TRI-COUNTY SCHOOL CORPORATION – JR-SR HIGH SCHOOL ADDITION AND RENOVATIONS Wolcott, IN 47995

ADDENDUM FOUR

Addendum Three (AD.04) to the drawings and specifications prepared by Gibraltar Design for Tri-County Jr/Sr High School Additions and Renovations for Tri-County School Corporation, Wolcott, Indiana.

5. Sheet P-202

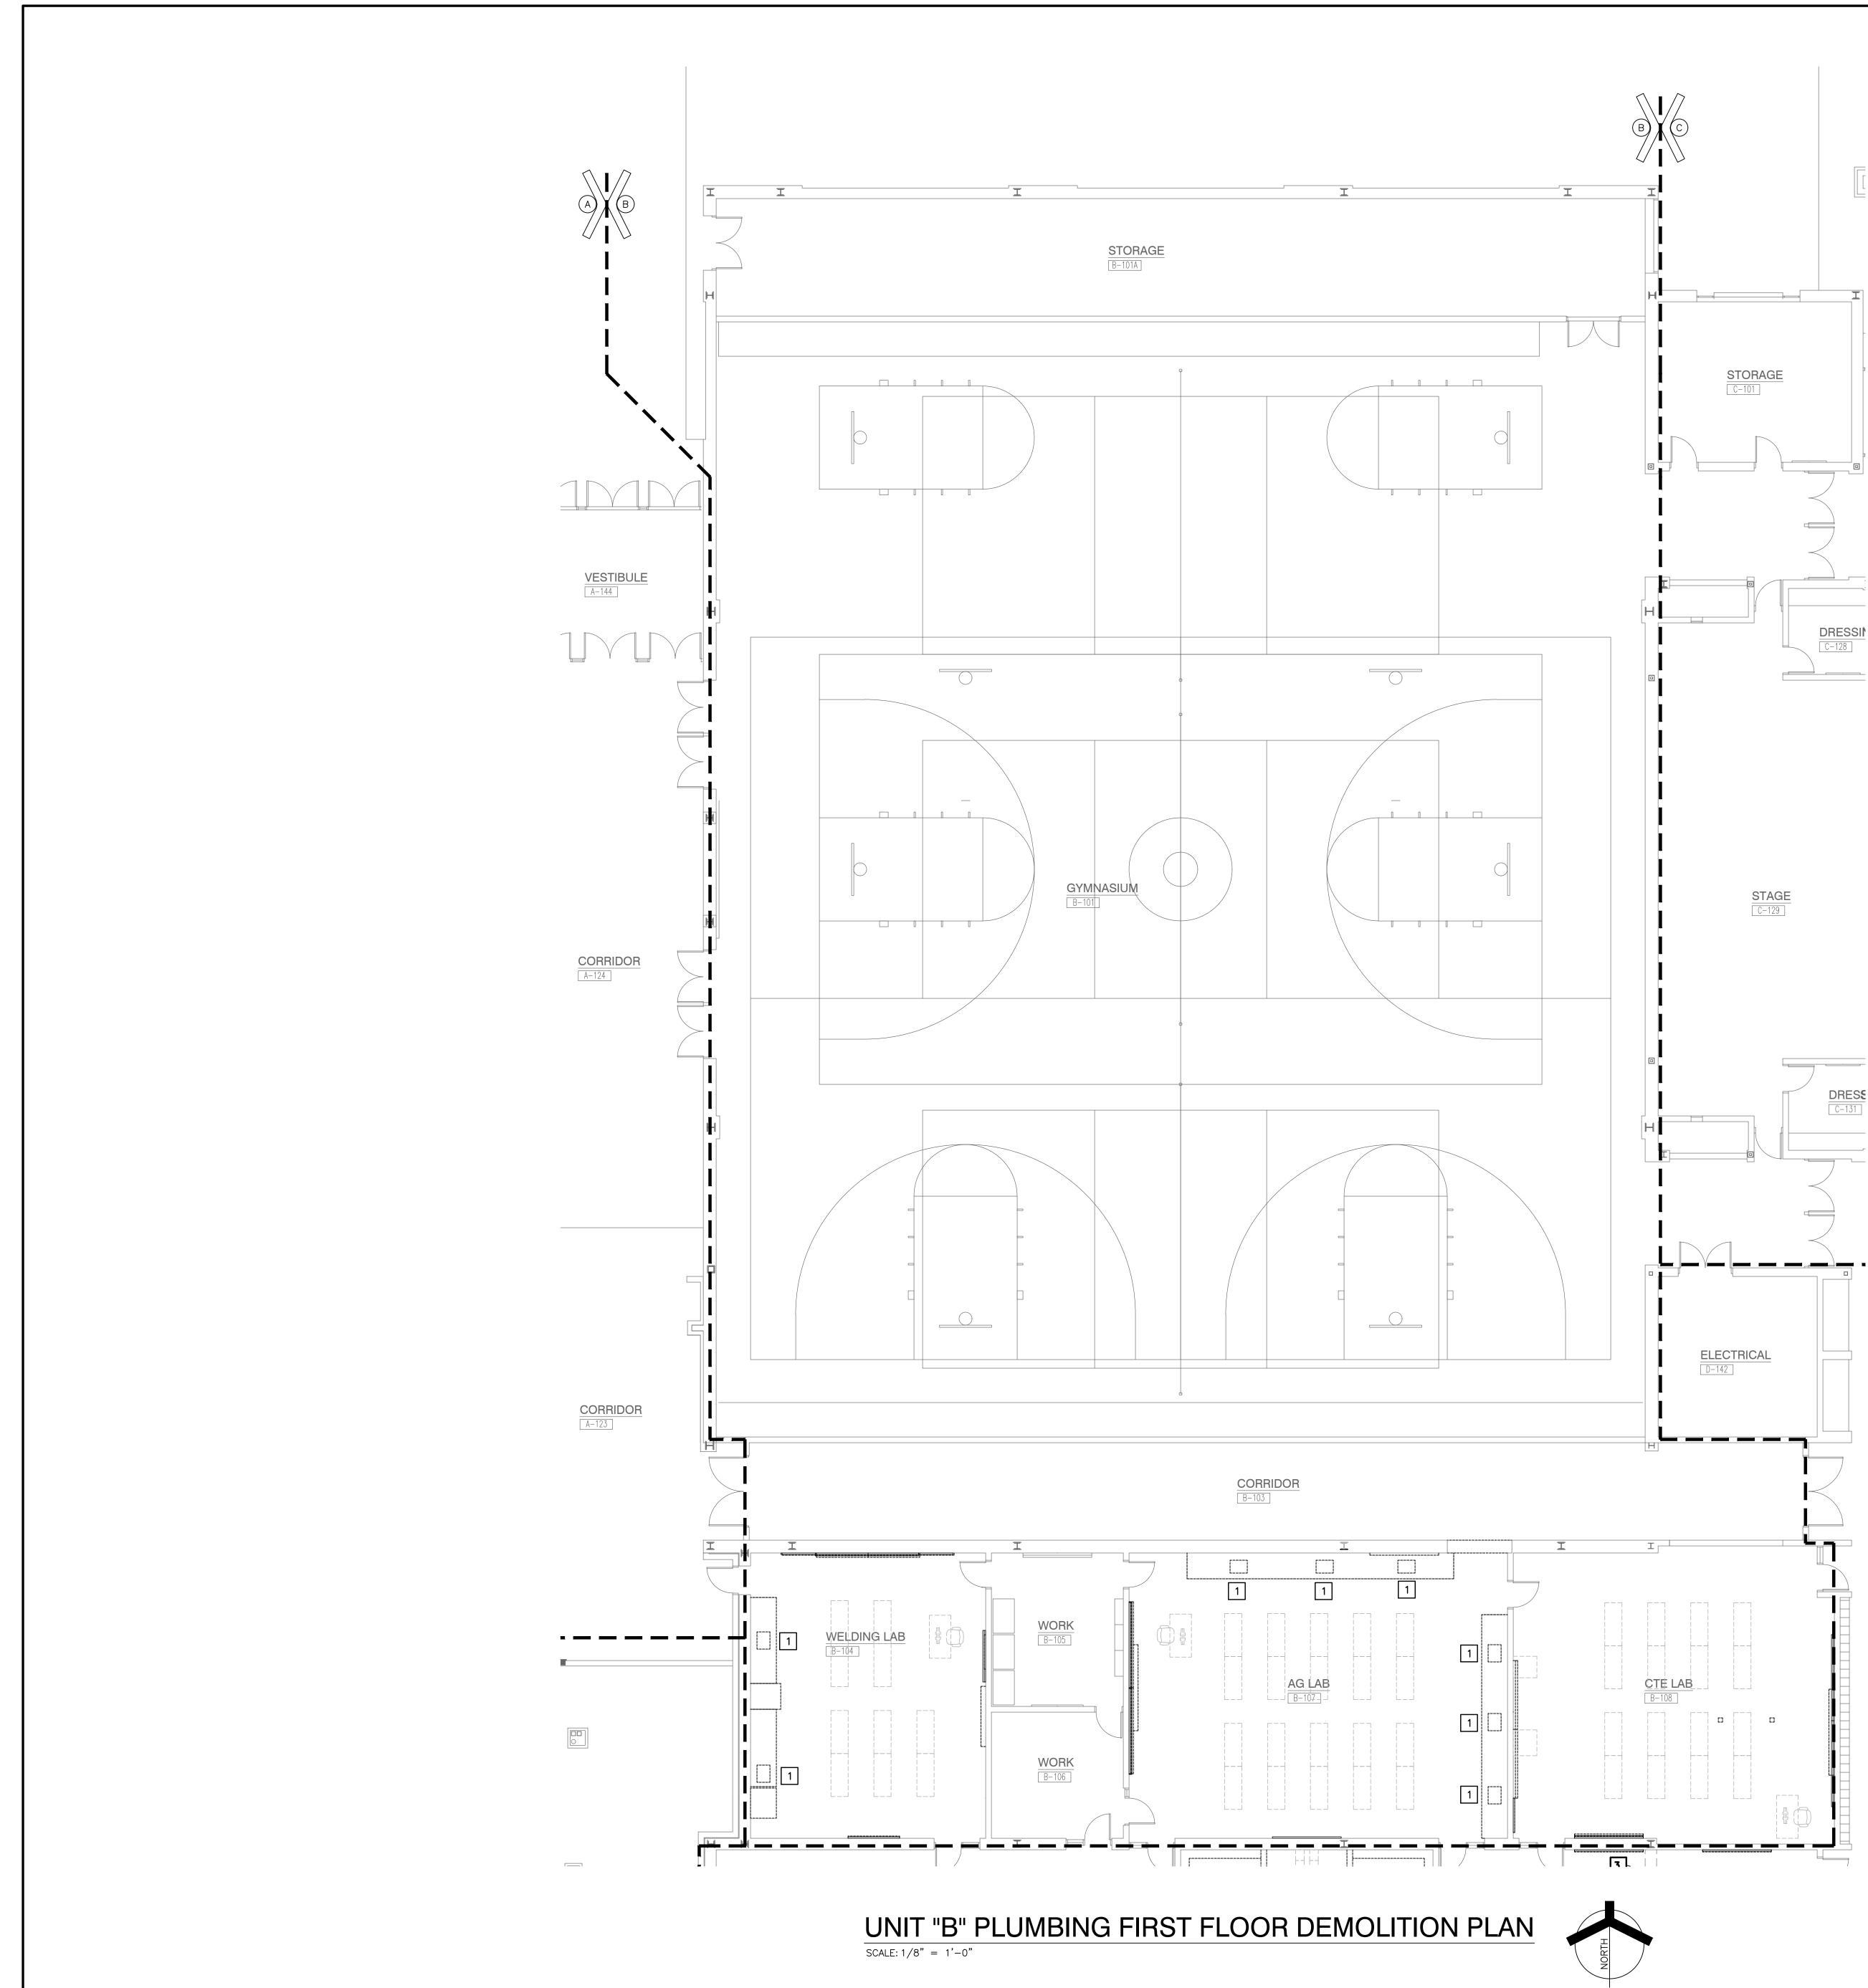
A. Add new sheet to the set to show new sinks in B-104 and B-107.

- 1 NEW PROPOSED SINK IN COUNTERTOP. CONNECT TO EXISTING WASTE, VENT AND WATER IN EXISTING WALL.
- 2 NEW PROPOSED SINK IN COUNTERTOP. CONNECT TO EXISTING WASTE, VENT AND WATER IN EXISTING WALL SERVING THE SINKS IN THE ADJACENT ROOM.

3. Sheet PD202

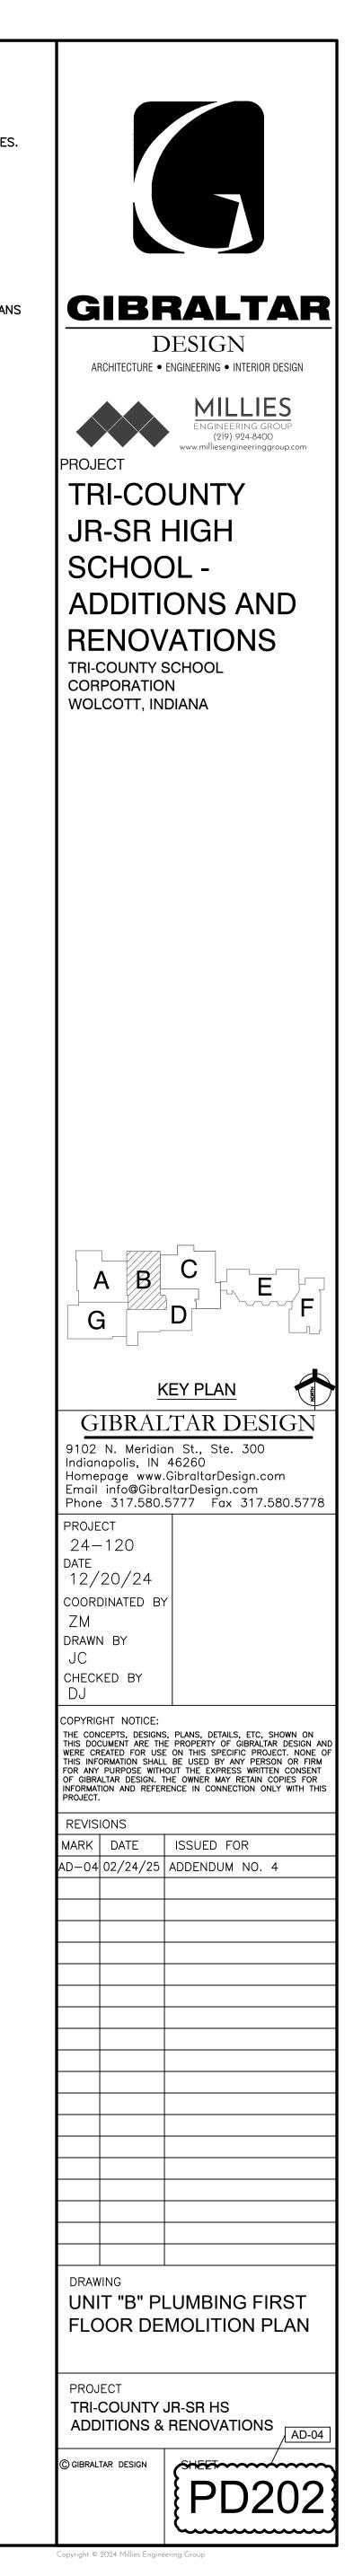
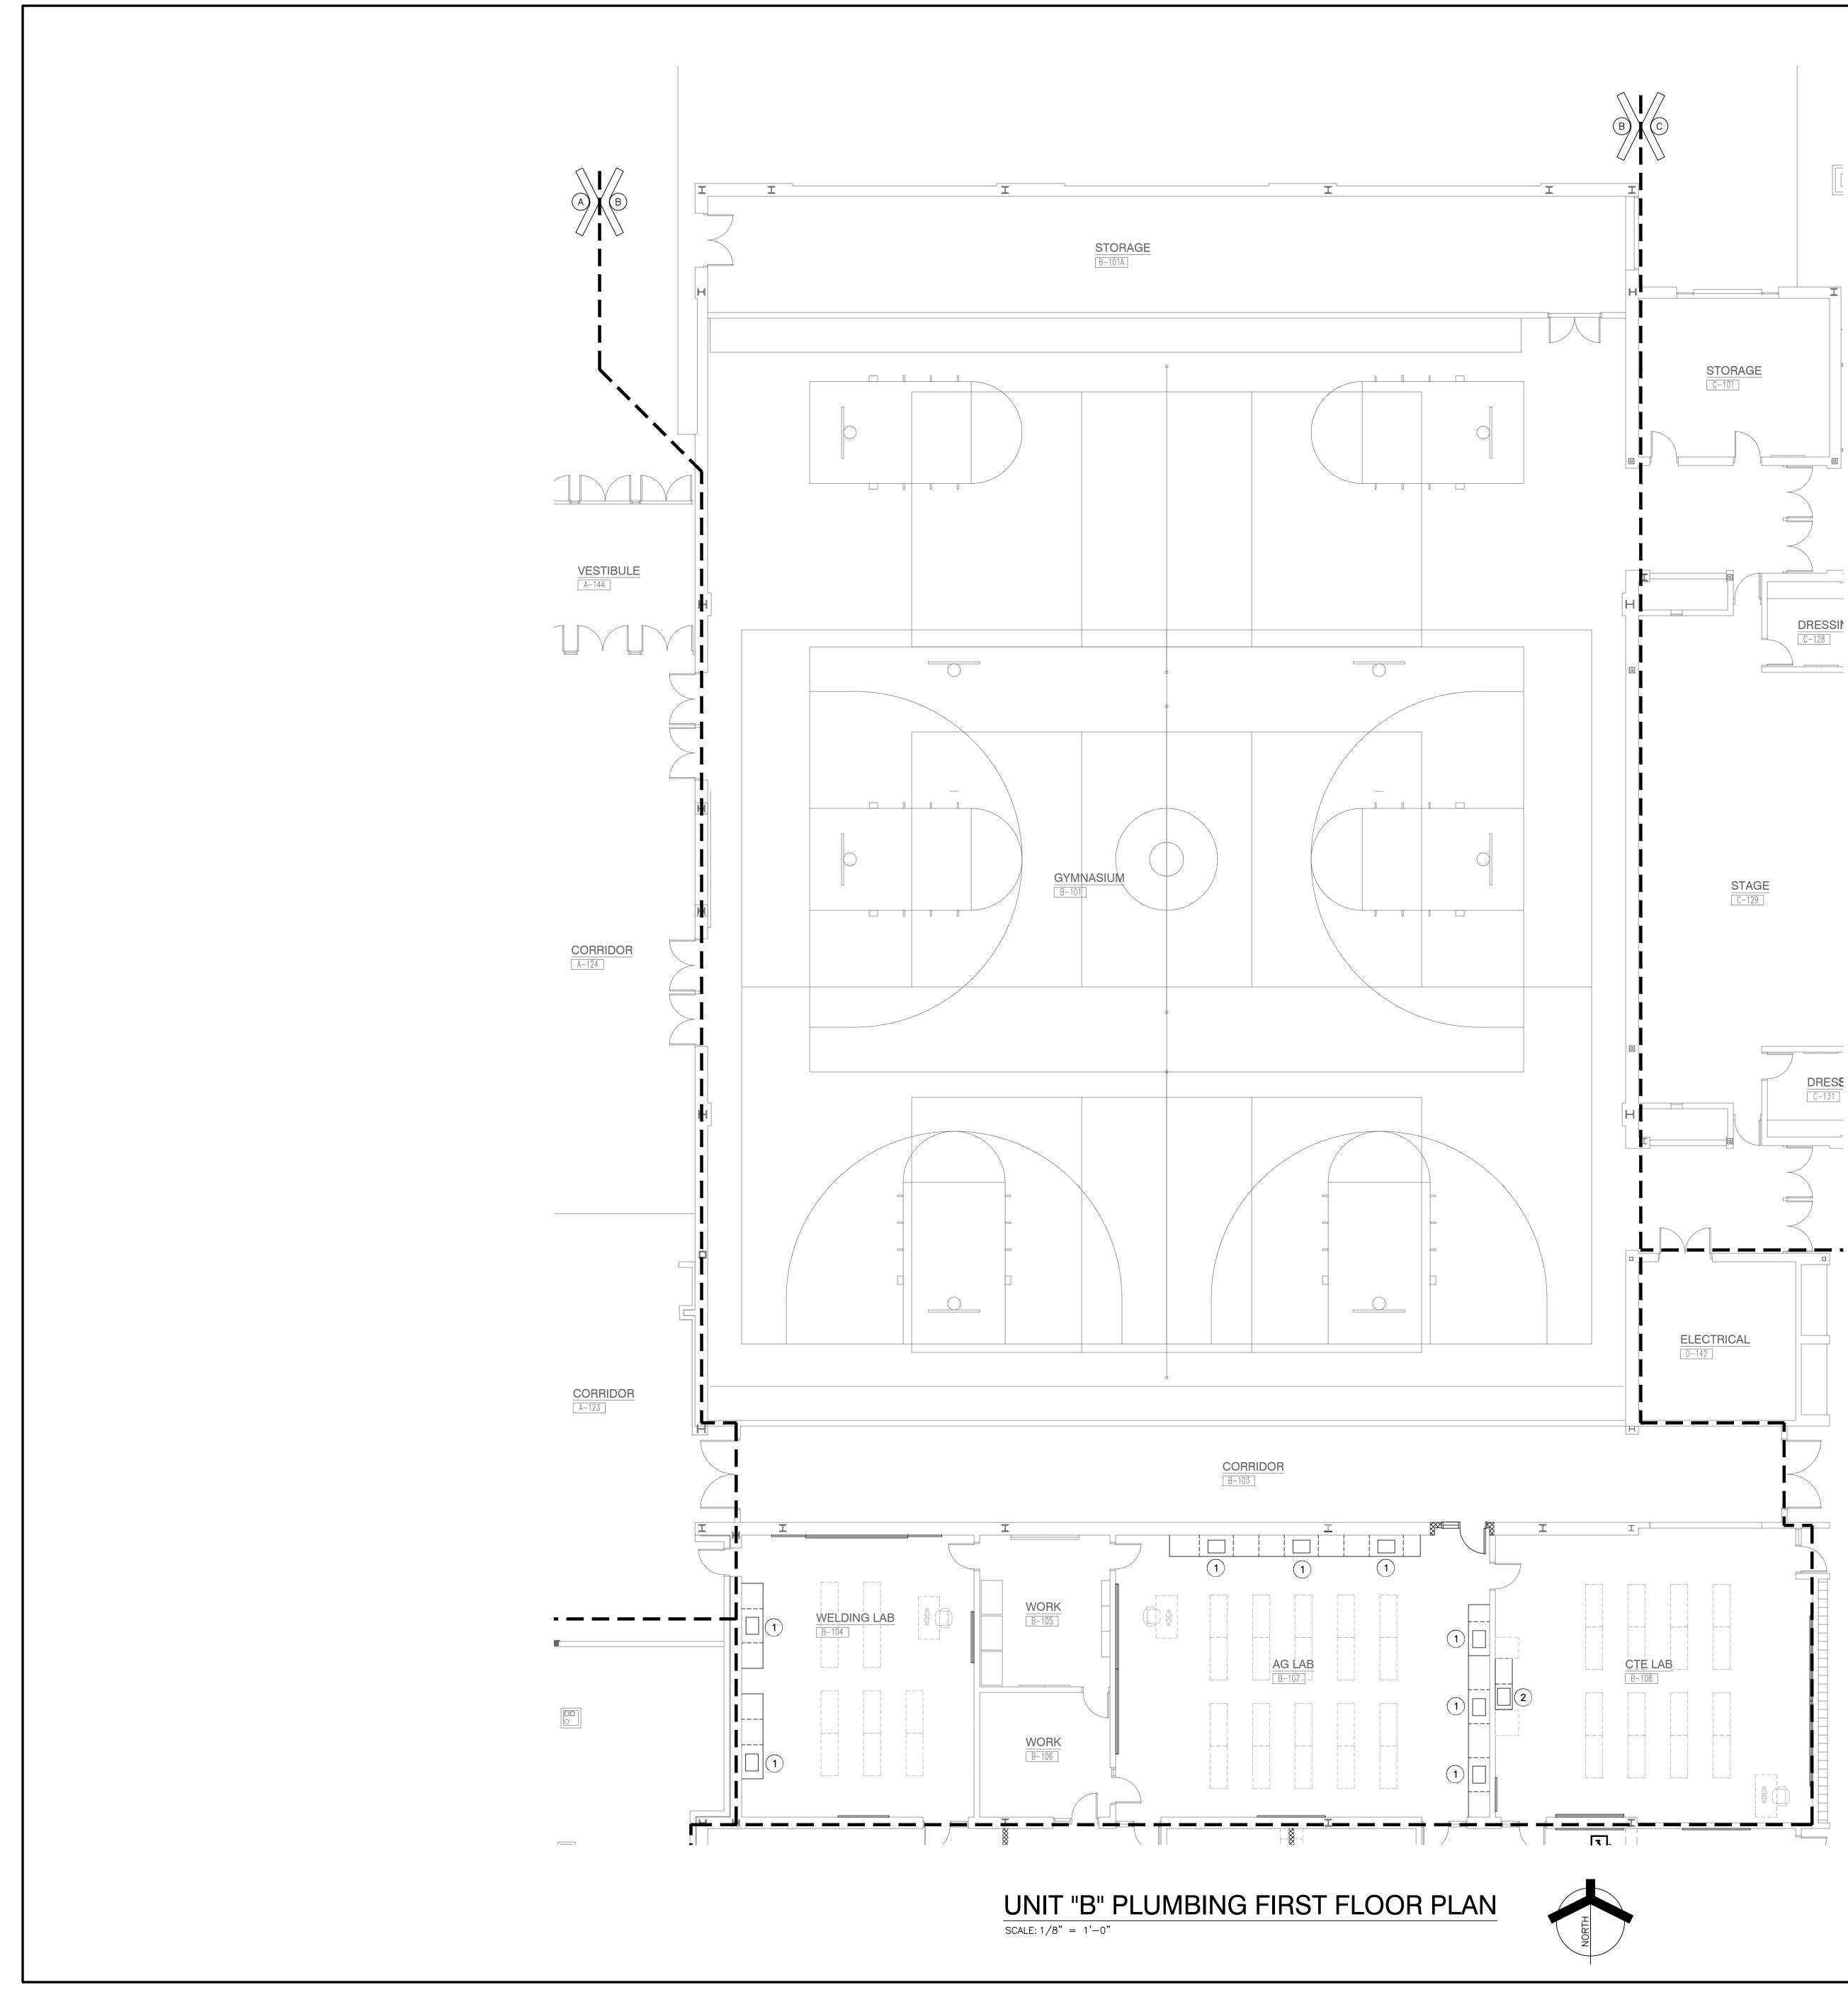
A. Add new sheet to the set to show demolition of sinks in B-104 and B-107.

1 REMOVE SINK AND VALVE AND REPLACE WITH NEW. SEE ARCHITECTURAL PLANS AND P-202 FOR PROPOSED LAYOUT.
